**Mansion Hill District of Capitol Neighborhoods**

**Steering Committee Report  
to the  
Landmarks Commission**

May 6, 2010

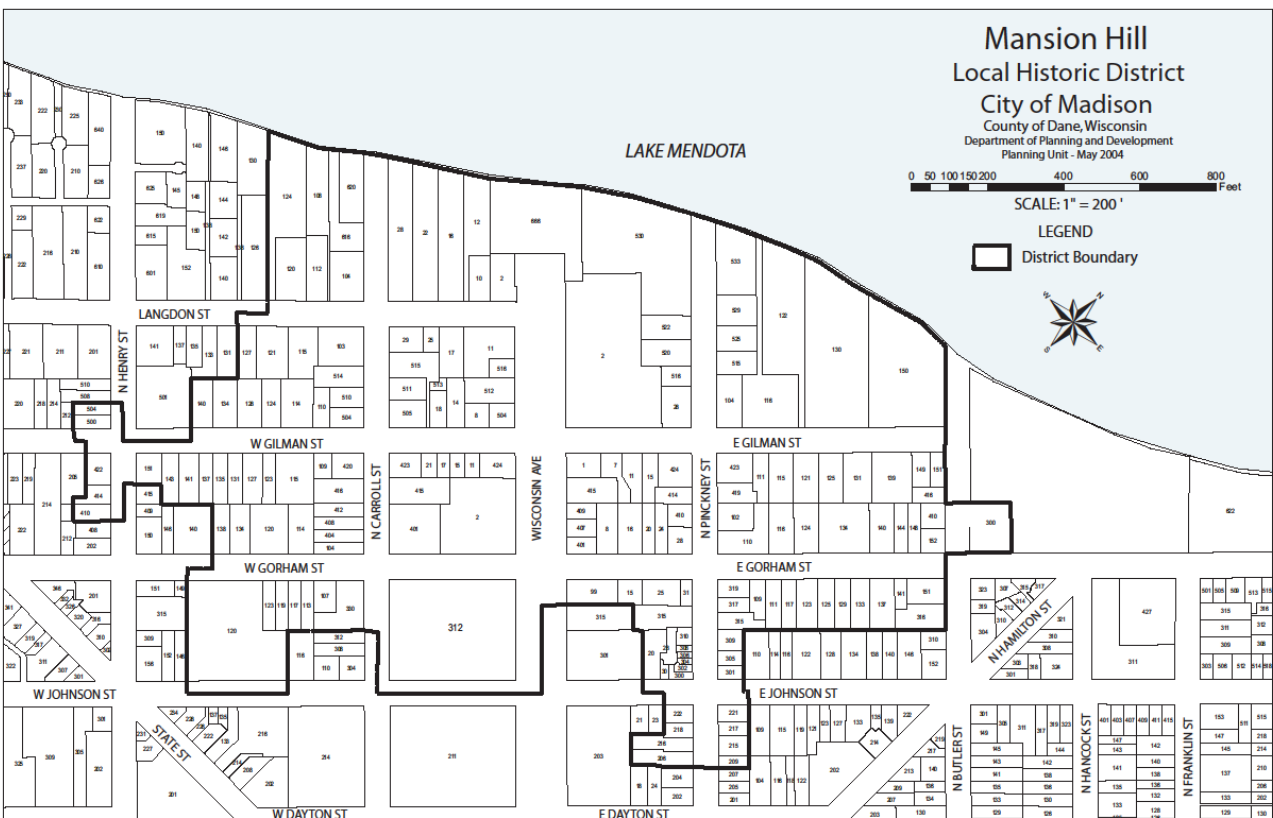
The developer places great emphasis on his plan to "restore" the glorious old Edgewater, but he apparently has no interest doing this, at least if we use the word "restore" in its preservation context. No one who proposes to restore an outstanding Art Moderne building would add a new top story done in the Bauhaus glass box style. Such an intrusion would make the new top story to the Inn on the Park look like an architectural gem.

Staff says in their report that such additions are "consistent with the objectives and design criteria contained within 'The Mansion Hill Historic Preservation Plan and Development Handbook'". However, that document requires that "In all matters regarding the issuance of Certificates of Appropriateness the Landmarks Commission shall act to work in the best interests of the existing structures in the Historic District." In terms of restoration of a historic building, the Secretary of Interior Standards for Historic Rehabilitation is clearly the benchmark for acting "in the best interests of" and "existing structure." While, staff says, it is not "essential for all of the alternations to comply with the Secretary of the Interior standards," if not those standards, then what standards and what process would be more likely to truly "restore" the Edgewater?

# DRAWING #1: March 2010 Proposal vs. October 2009 Proposal

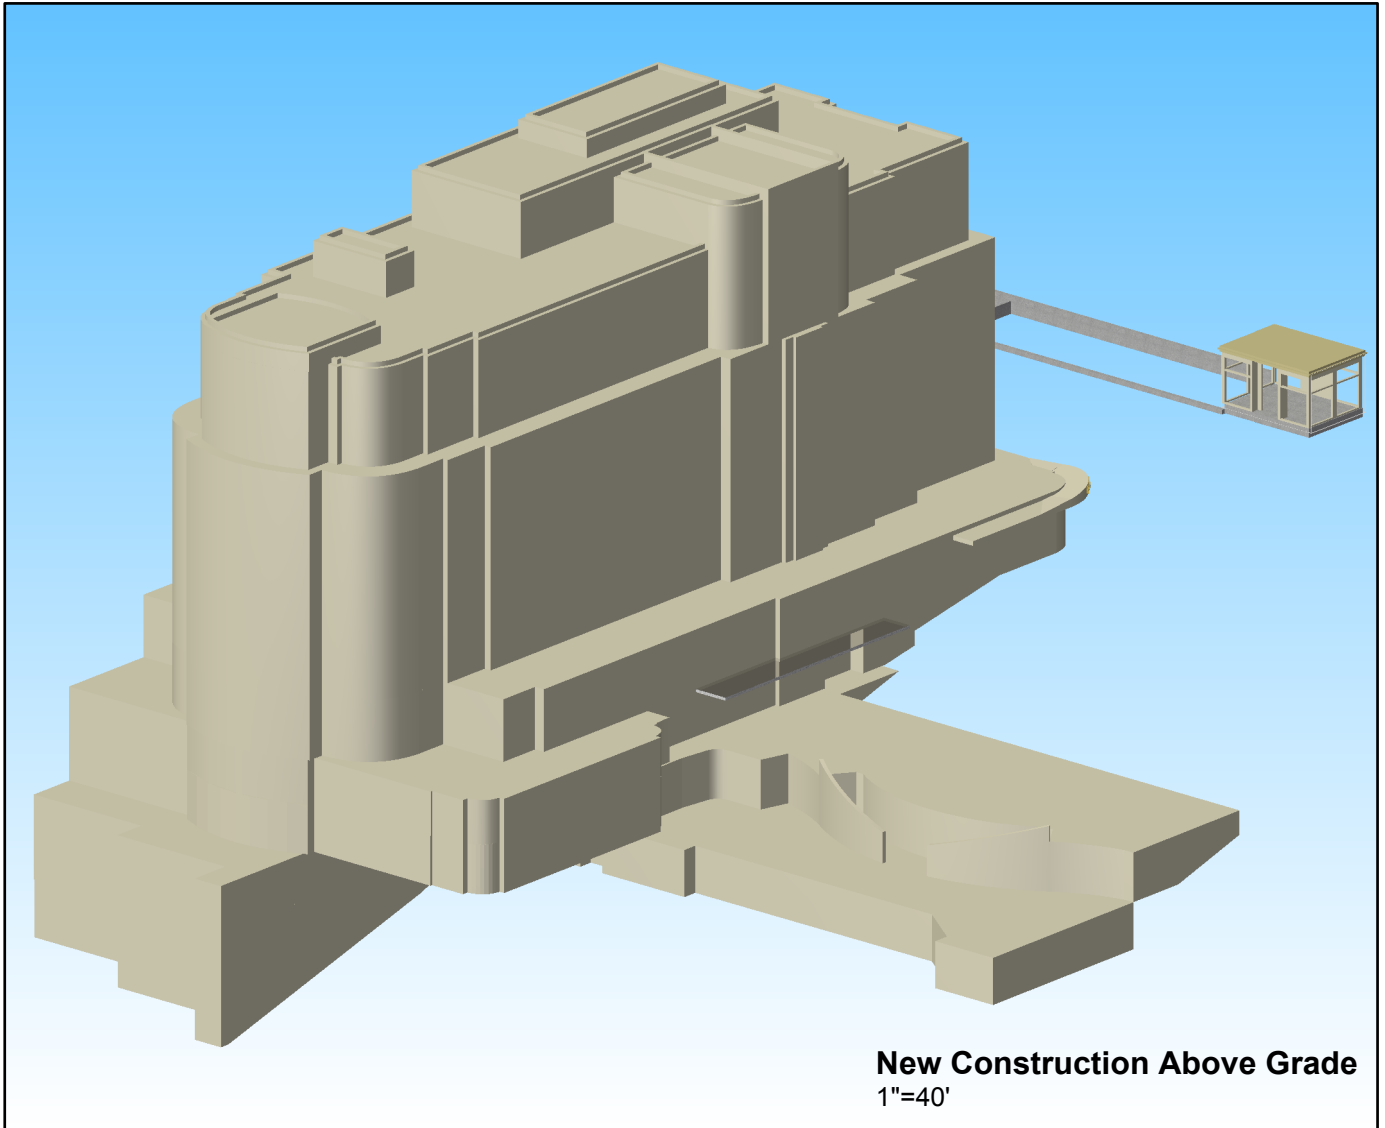
The current proposed Edgewater hotel edition is wider, longer, and taller; has more square footage and volume, and is closer to both Lake Mendota and to Langdon Street than the previous version that was rejected by the Landmarks Commission because of its mass. Considering its full 14 stories, it is more than five times the height of the average building in the Mansion Hill Historic District (See Drawing #1.)
